**STAFF REPORT**  
**(Preliminary Plat)**

**CASE NUMBER:** S/D 96-14 SPRING CREEK ADDITION

**STAFF REPORT**  
(Final Plat, Preliminary Plat Approved 4/4/96)

**CASE NUMBER:** S/D 96-14 SPRING CREEK ADDITION

**VICINITY MAP:**

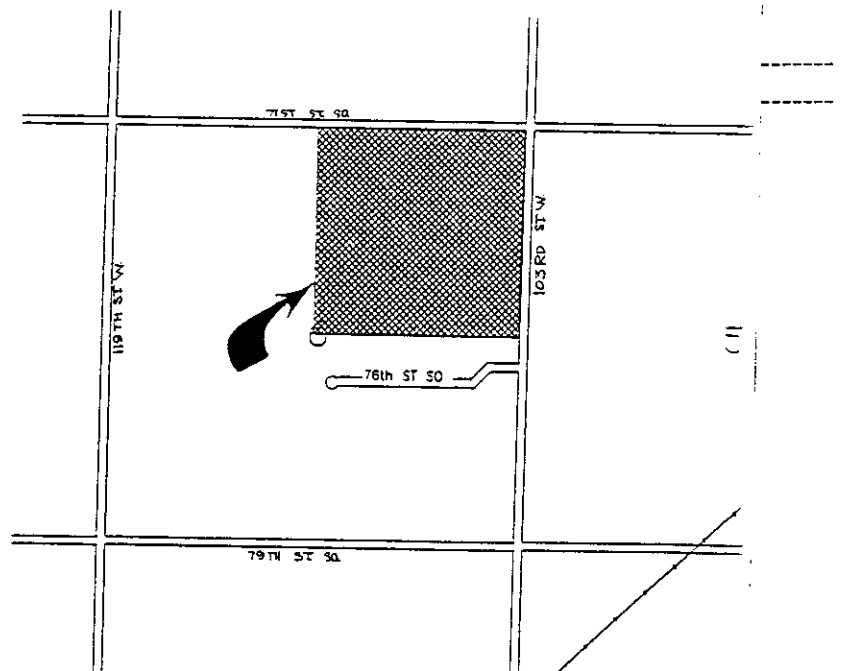
- D. In order to provide for emergency access for the overly long cul-de-sac street (Bluewater Lane), the applicant has indicated that an access easement will be provided from the end of this street, southward across the adjoining property to an existing street that also extends out to 103rd Street East.

- H. The **County Fire Department** representative needs to indicate the acceptability of the indicated street names. Spring Creek Drive is already in use in the County, but is in the area just south of Kellogg and near Butler County. If Bluewater uses the Lane designation, the two courts should also use "Lane" in their name. Also, Bluewater Lane since it is ending in a cul-de-sac would need to be labeled a circle, i.e., Bluewater Lane Circle. It may be more appropriate to simply call these streets Bluewater Circle and Bluewater Court(s). Spring Bluff would also be

- I. Although the Subdivision Regulations do not directly cite lot standards in regard to fragmentation of lots, it is appropriate to avoid any such situations. Lot 4 and a portion of Lot 8, both in Block 1, are divided by a floodway, in particular Lot 4. It does not appear that the Floodway at these locations is so extreme as to isolate portions of these lots in any significant manner. If, however, the floodway is actually impassable, it is recommended that a realignment of lots be considered so as to eliminate any such fragmentation.

**VICINITY MAP:**

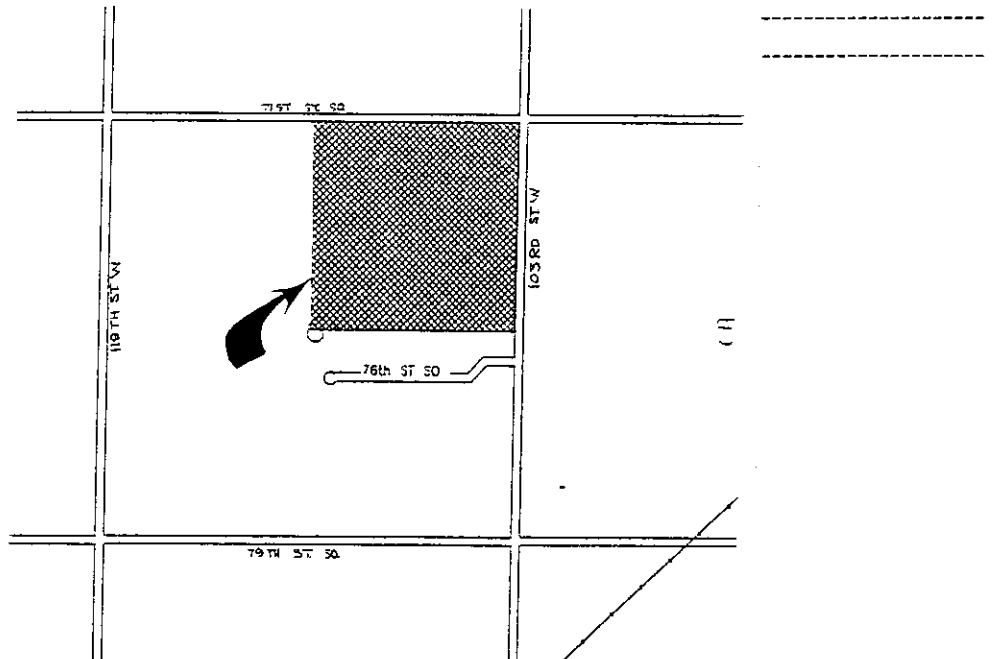
- D. In order to provide for emergency access for the overly long cul-de-sac street (Bluewater Lane), the applicant has indicated that an access easement will be provided from the end of this street, southward across the adjoining property to an existing street that also extends out to 103rd Street East. This easement needs to be submitted to Planning for processing with the plat. Also, the final plat shall redesign this cul-de-sac so that it is fully in contact with this easement.

- E. The applicant's agent needs to explain how this plat is proposing to depict lot perimeters for those lots adjacent to the indicated floodway. At this time, the final plat is apparently showing non-specific and unacceptable descriptions of lots along the floodway(s). That is, the rear lot lines of these lots are not being precisely identified. The dashed lines toward the rear of such lots appears to indicate the floodway boundary but not rear lot lines.

On the final plat tracing, all lot property lines should be properly indicated and the boundary of the floodway(s) labeled as such.

- F. The plat's text shall be amended to note that access controls are being dedicated to Sedgwick County. This site is distinctly a County location, with no expectation of being incorporated into an urban area in the near future.
- G. The plat's name "Spring Creek Addition" shall be placed on both pages of the plat.
- H. On the final plat tracing, "Spring Bluff" coming off of 103rd Street West shall be labeled a

- I. Although the Subdivision Regulations do not directly cite lot standards in regard to fragmentation of lots, it is appropriate to avoid any such situations. Lot 4 and a portion of Lot 6, both in Block 1, are divided by a floodway, in particular Lot 4. It does not appear that the Floodway at these locations is so extreme as to isolate portions of these lots in any significant manner.
